January 2014

V9xx/SN6xx Series Cameras Firmware

Correct pink picture on V923B camera

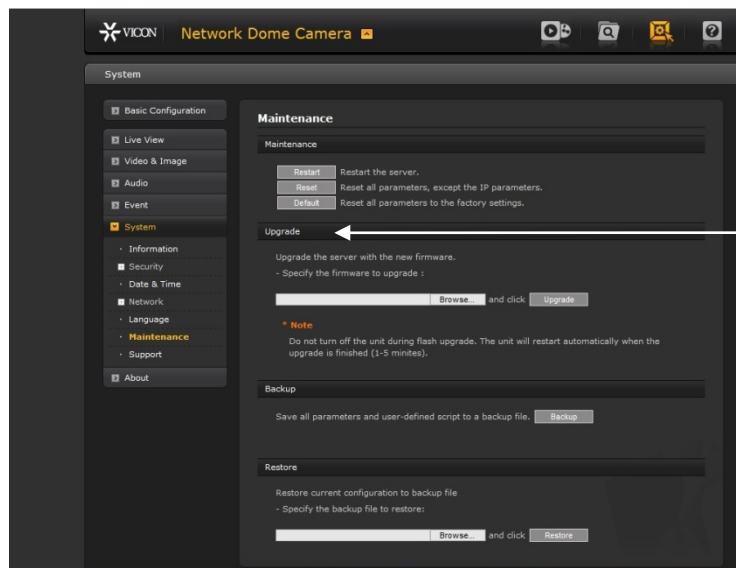
On this specific model only the older firmware provided a pink picture.
